**From:** Chris McCall <cmccall@villagebhi.org>  
**Sent:** Thursday, April 21, 2022 3:27 PM  
**To:** alanbriggs1; Carol Collins  
**Cc:** Peter Quinn  
**Subject:** Village Comments Post-BHA Board Meeting & Mr. Gravatt's Presentation on 4/18...  
**Attachments:** Lot 1319 LiDAR Contour Elevation Dune Profile Map\_COPY\_21 APR 2022.jpg; Access 15\_17\_Adjacent Widths-Visuals\_COPY\_20 APR 2022.pdf; E911 Beach Access LiDAR Contour Elevation Dune Profile Map\_21 APR 2022.jpg

Alan & Carol – as a follow up to Monday's public information meeting and in reviewing Mr. Gravatt's presentation I wanted to offer on behalf of the Village the following comments (and referenced attached files) for consideration and will leave it to your discretion as to who & how you provide these comments (i.e., BHA Board, ARC, Association members and others etc.)..., thank you in advance;

Along Peppervine Trail – 6 Private Beach Accesses in less than 500’ feet crossing the frontal dune (and with several of the access falling well short of the seaward side of the frontal dune to the Fir

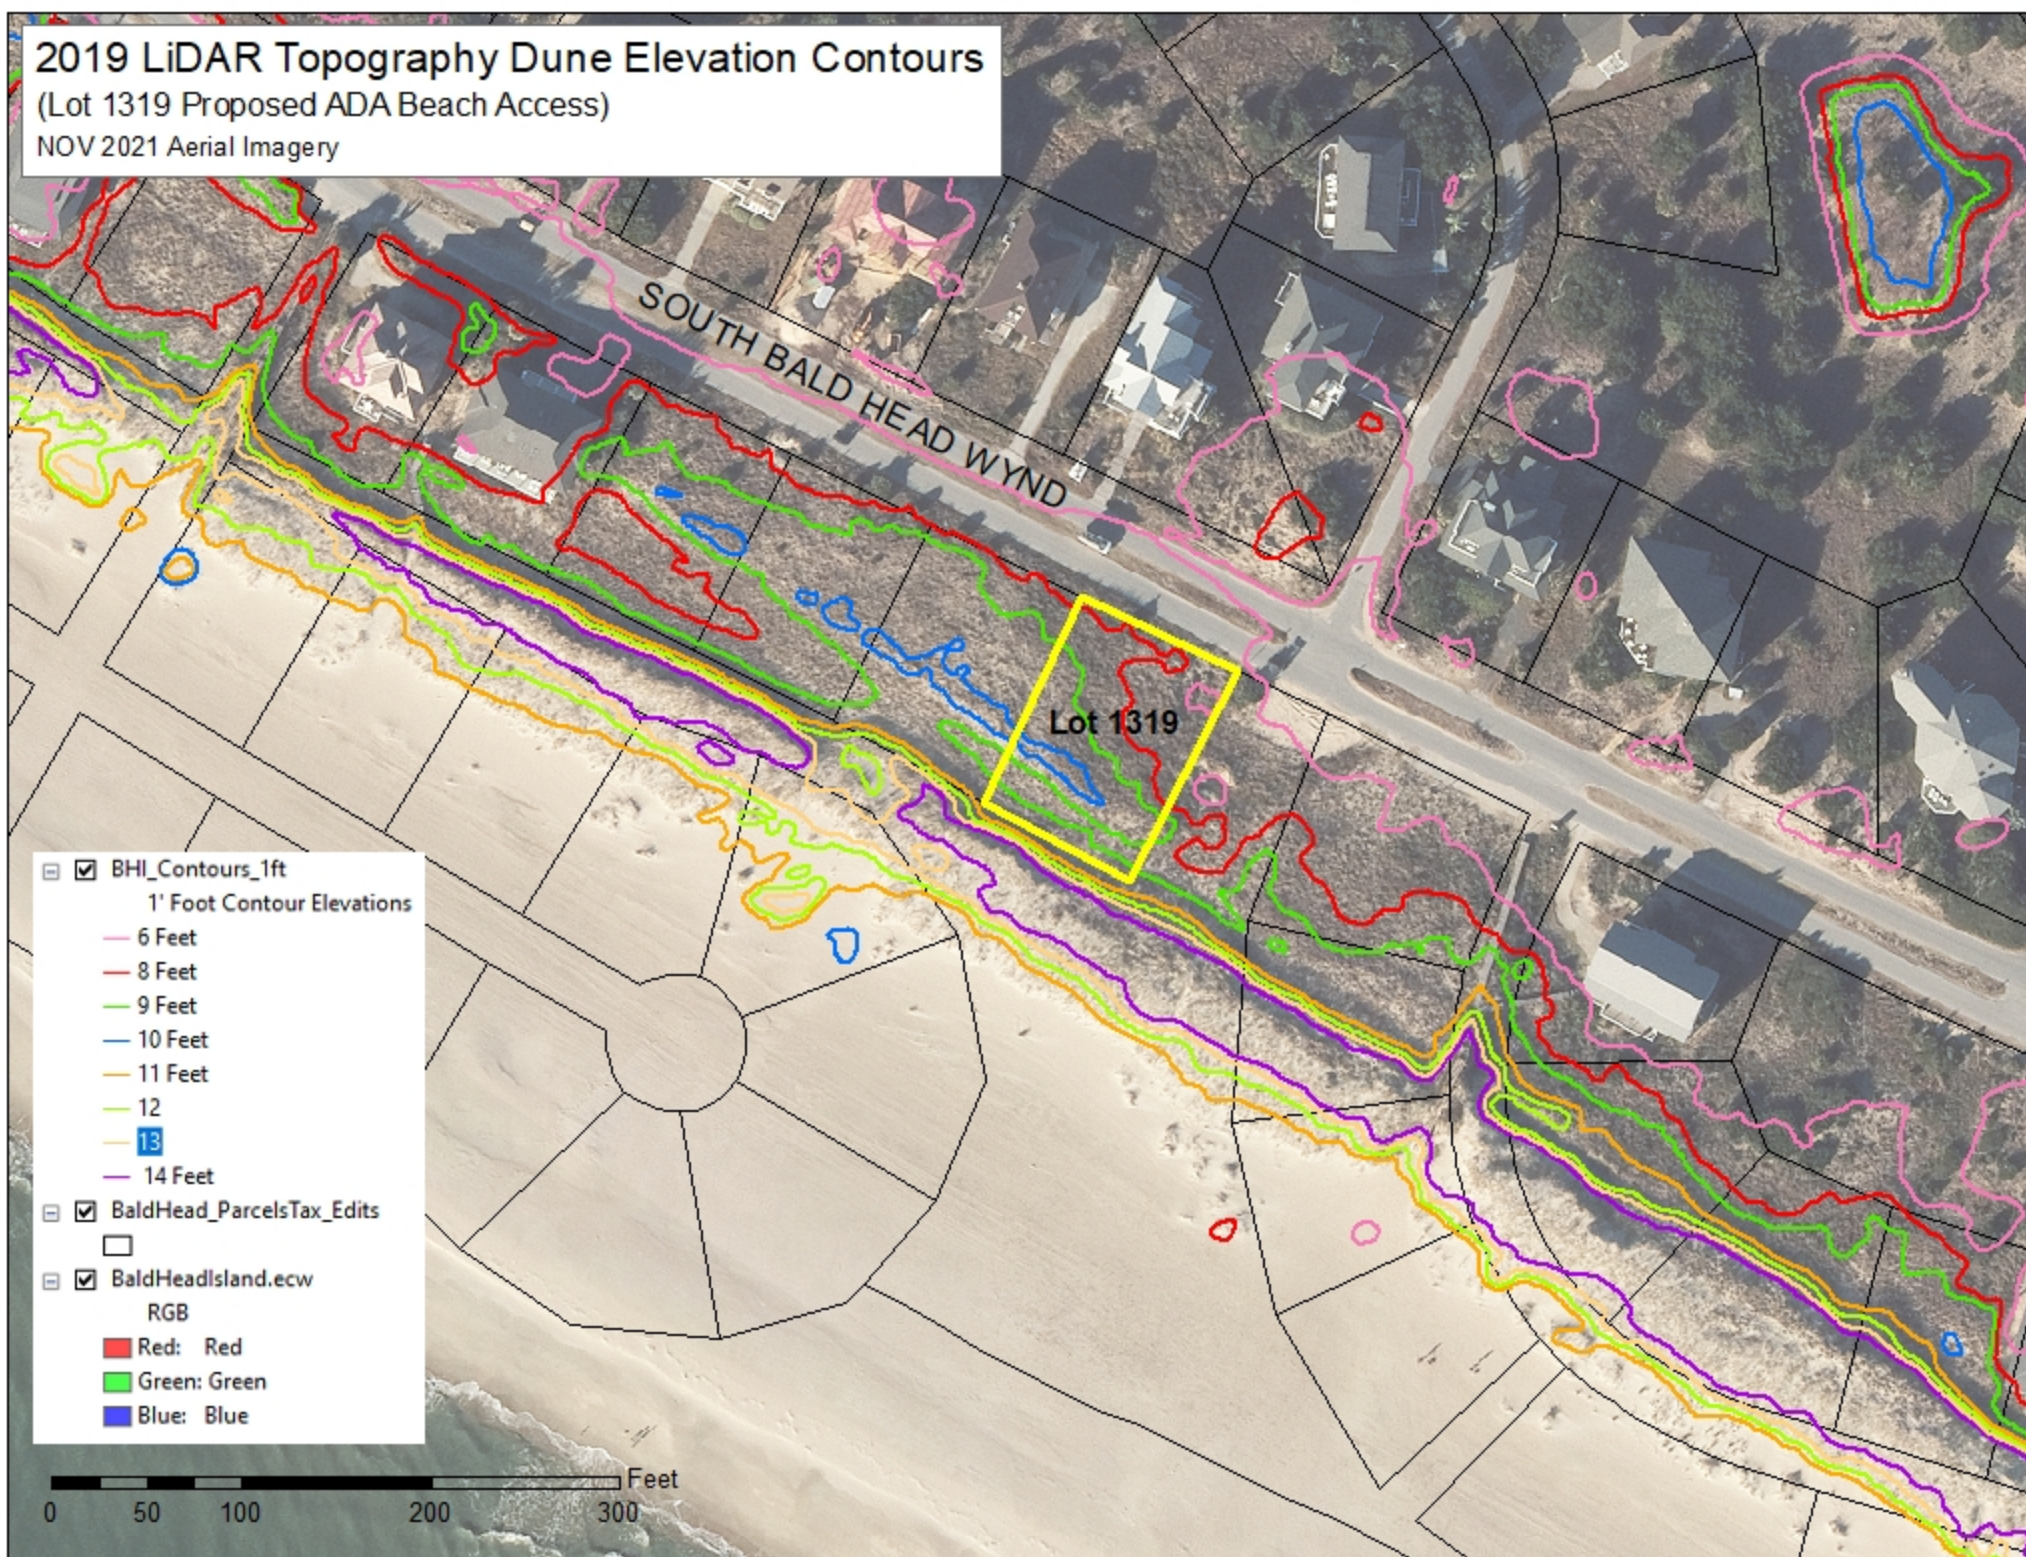
3. **Slide# 6** – All things relative to a 3.5 square mile island, beach accesses are a need and there are many instances where existing beach accesses have been constructed in close proximity to one another. Case in point, the image below shows how many beach accesses are present just within 500’ feet that cross the frontal dune and BHA “common area”. The Village’s request is not something new or that hasn’t already been done in other areas along the oceanfront shoreline.

# 2019 LiDAR Topography Dune Elevation Contours

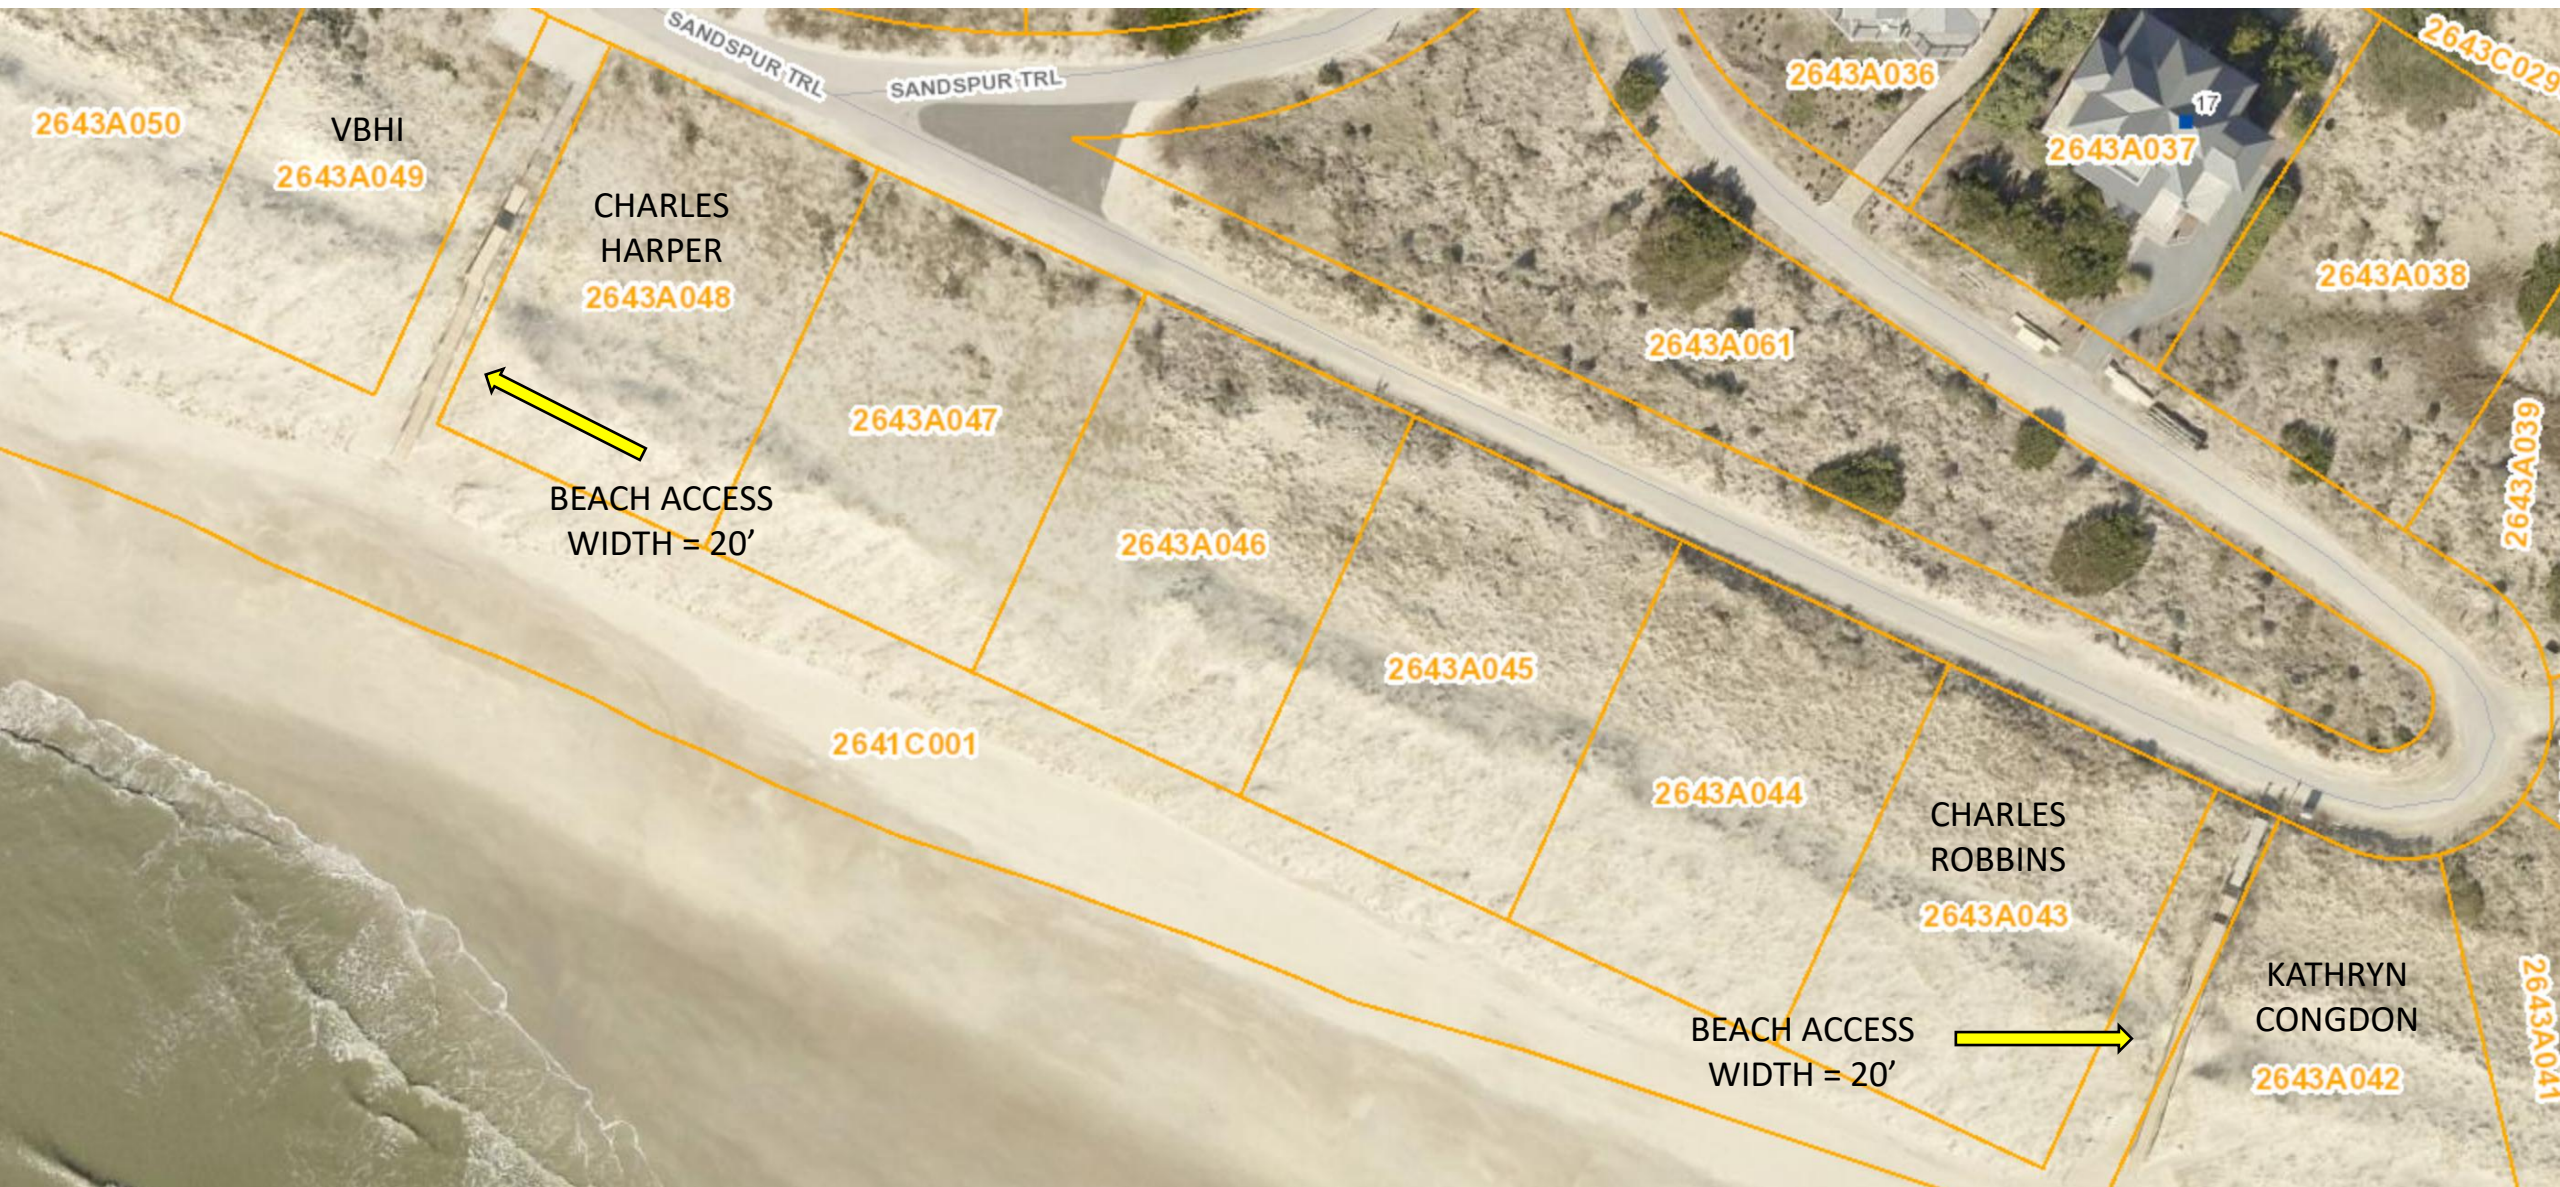
- Bullet# 3** – “Steep grade of dunes” – irrespective of the Village's efforts to show a side elevation/profile on the plan there continues to be this assertion that the structure is going to be excessively high/tall at 14' feet without consideration of the existing grade elevations at both the landward and seawards ends of the structure. The grade elevations based on LiDAR data show a net increase of approximately 5' feet in elevation to cross over the frontal dune.  
(Note: for reference attached is a “Lot 1319 LiDAR Contour Elevation Dune Profile GIS Aerial Map”).

7. **Slide# 10** – again, emphasis on the “observation platform at 16’ feet in elevation” being nearly two stories does not take into consideration the surrounding/existing grade elevations of +/- 8’-9’ feet on the landward and seaward ends of the frontal dune system. For purposes of responding here, again I have attached a GIS aerial map showing the 1’ foot contour elevations above mean sea level from elevations of 6’ feet to 14’ feet.
